**Final Drainage Report Addendum
Peaceful Ridge at Fountain Valley Subdivision
El Paso County, Colorado**

Kiowa Project No. 04092 & 21031

Please add "PCD File No. CDR-22-015".

PEACEFUL RIDGE AT FOUNTAIN VALLEY
EARLY GRADING PLAN
INITIAL GRADING AND EROSION CONTROL PLAN
EL PASO COUNTY, COLORADO
FOUNTAIN VALLEY INVESTMENT PARTNERS, LLC

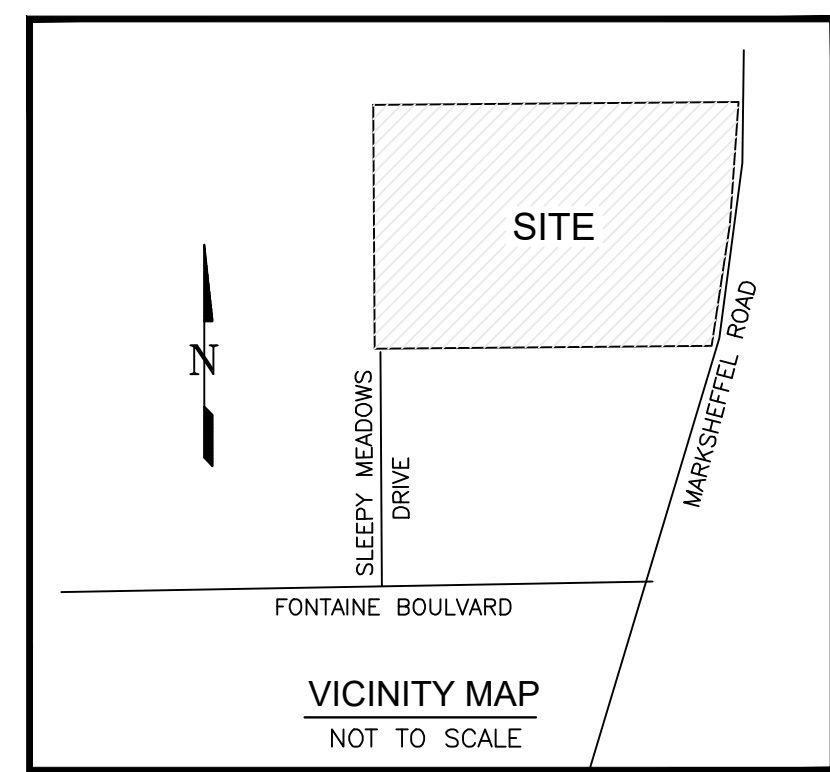
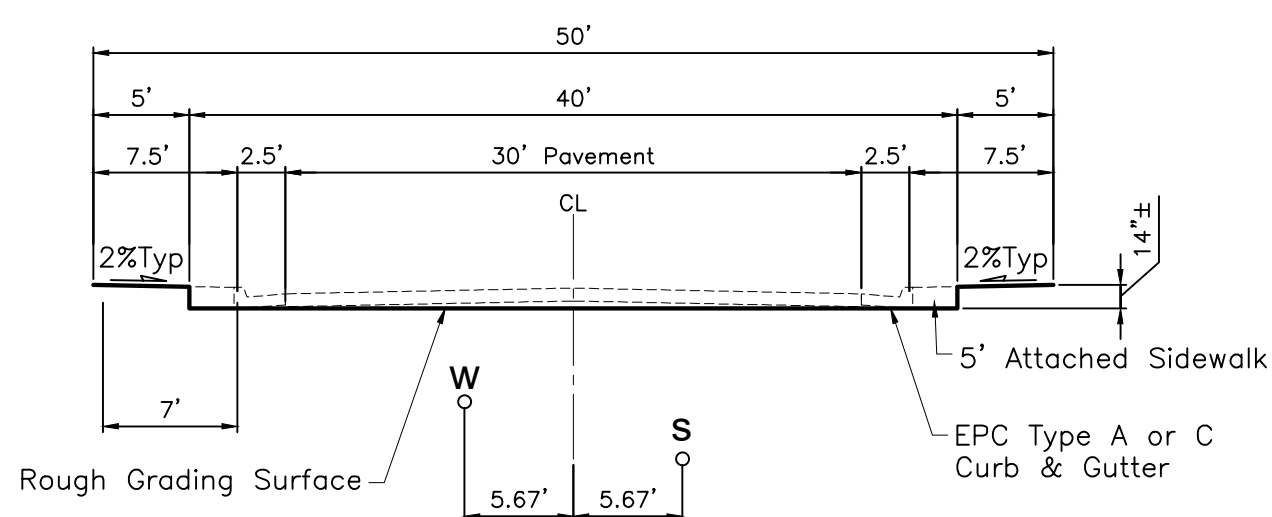
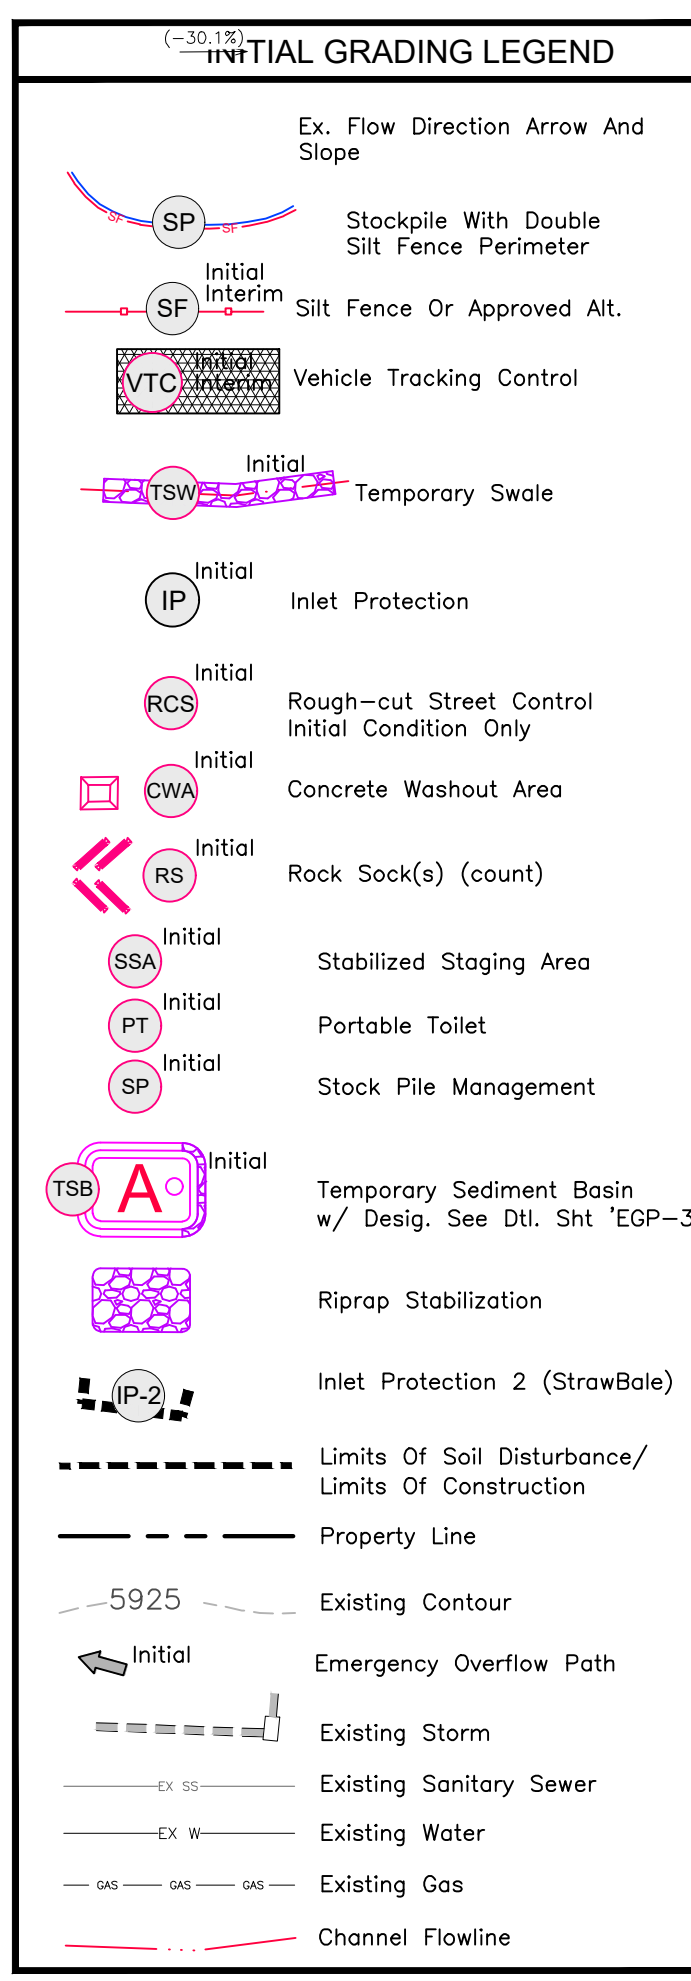
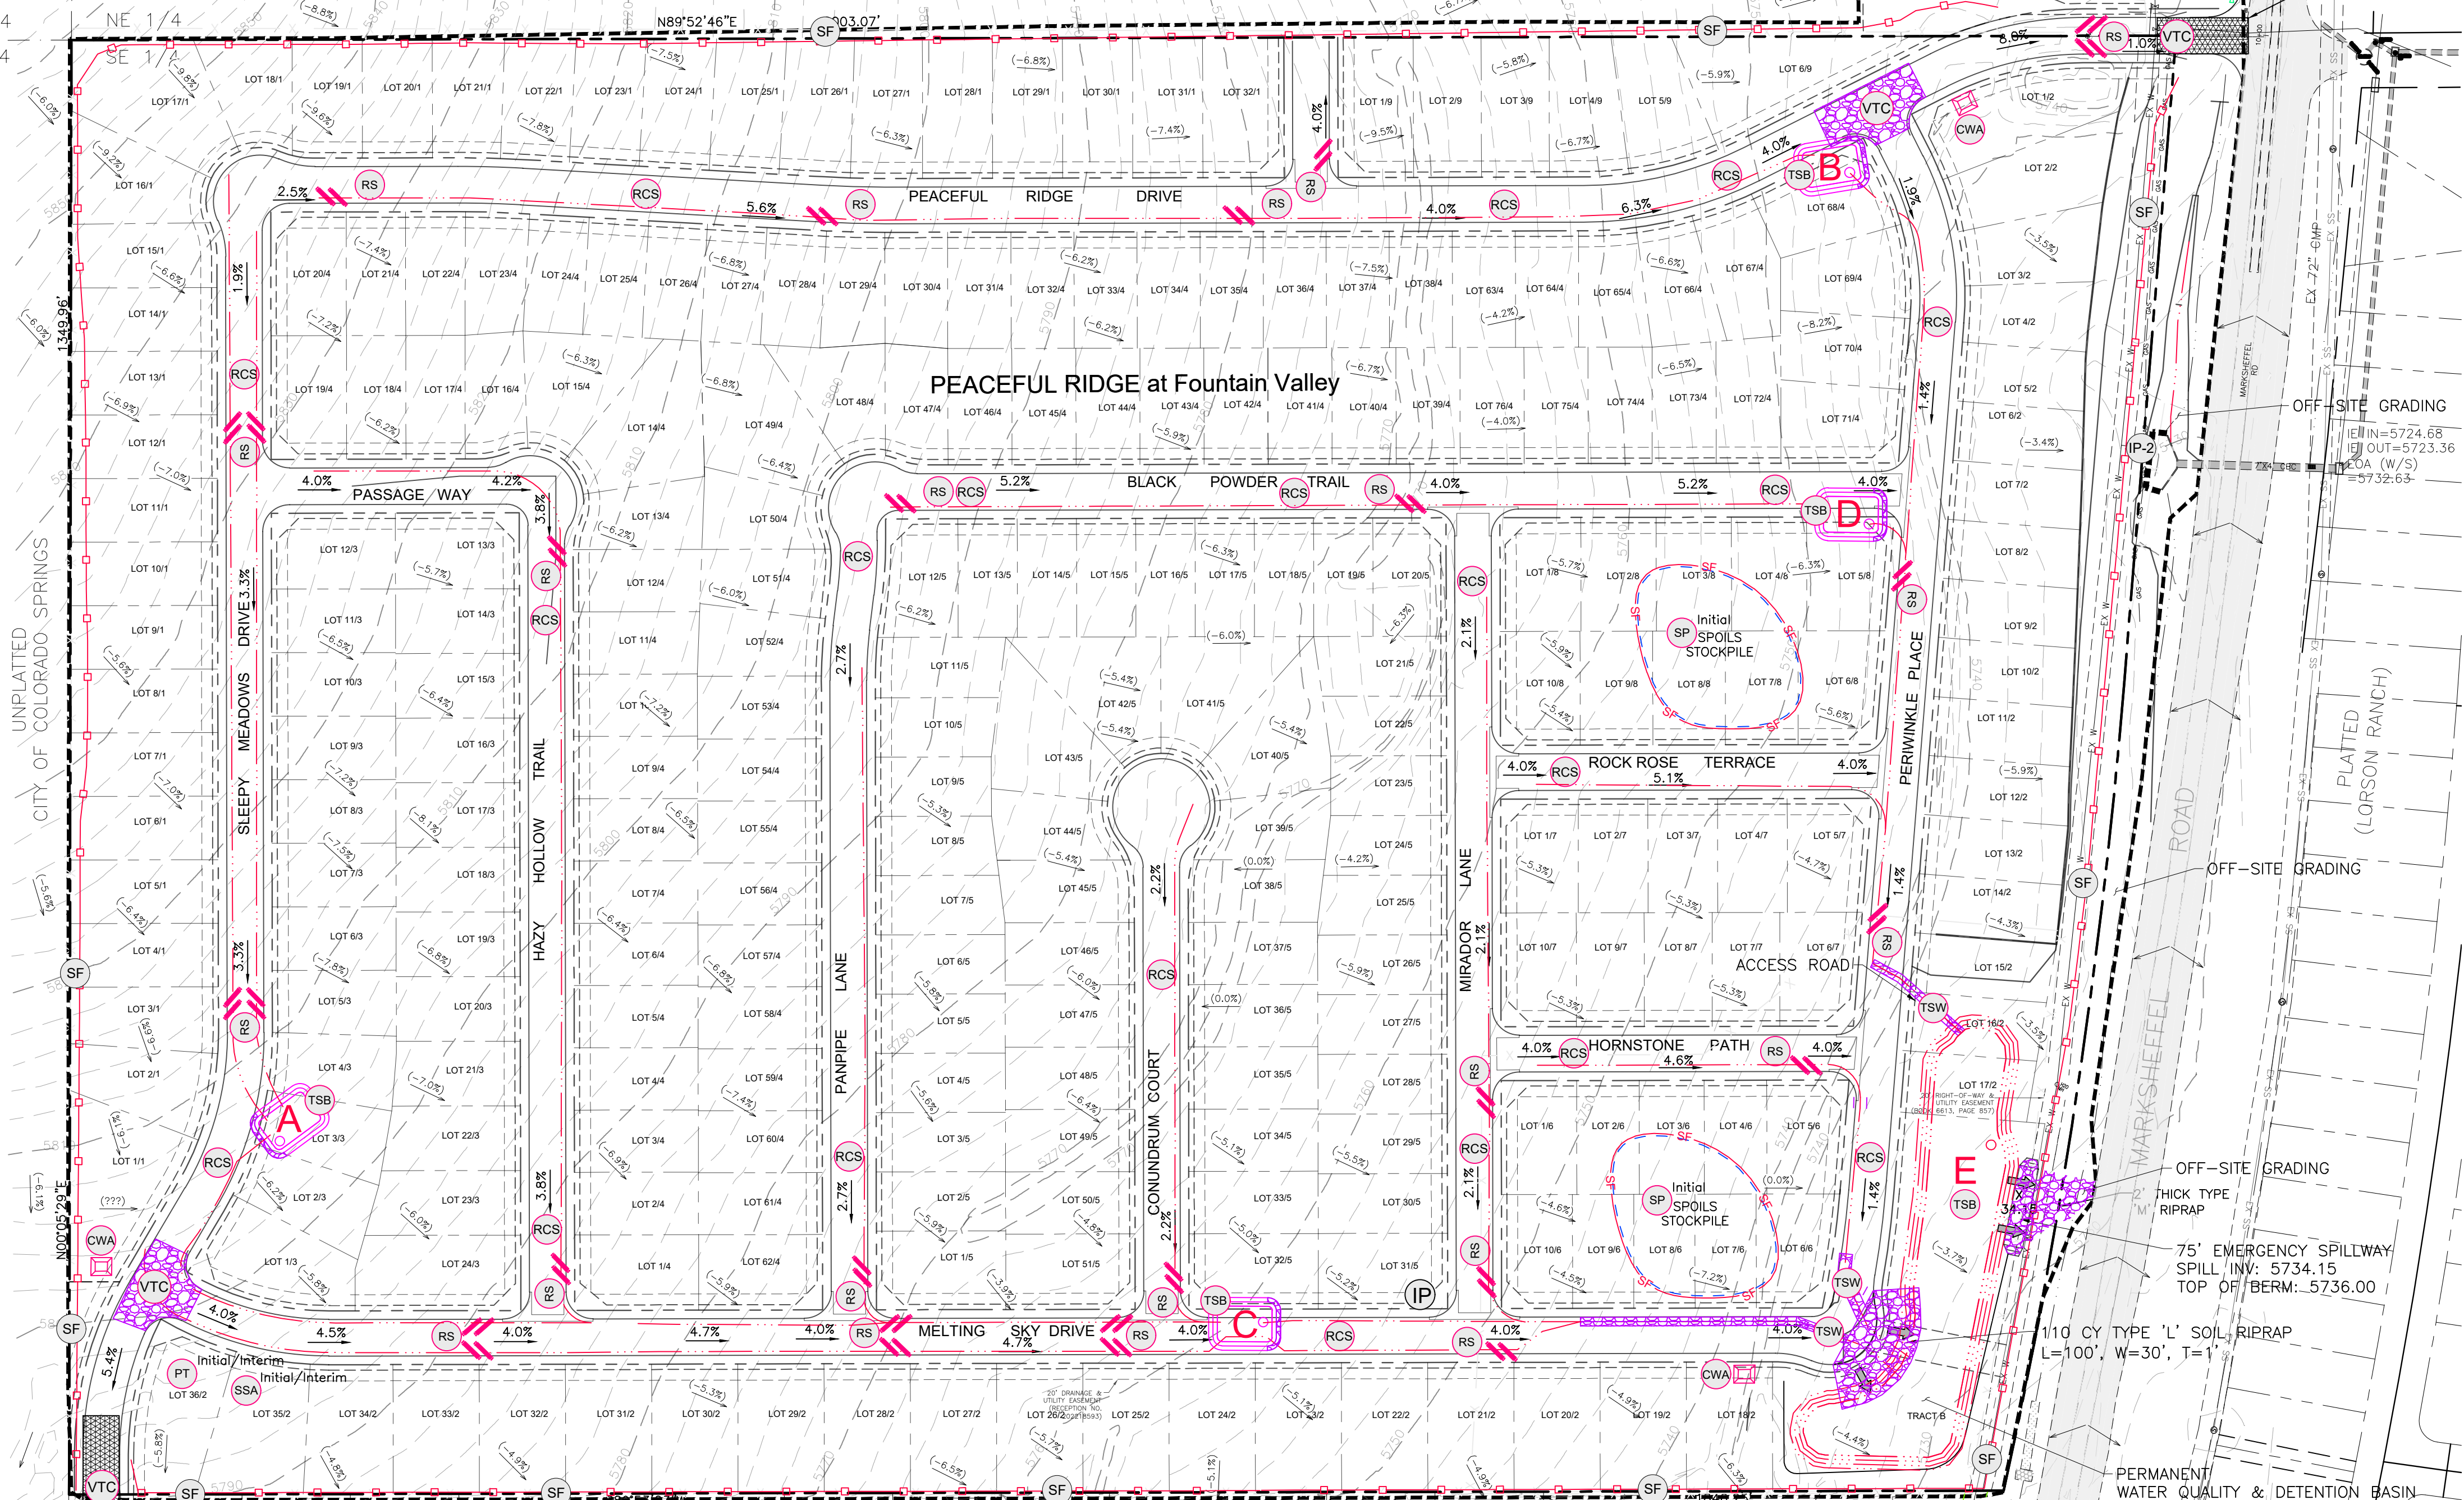
Remove grading sheets and details from drainage report.
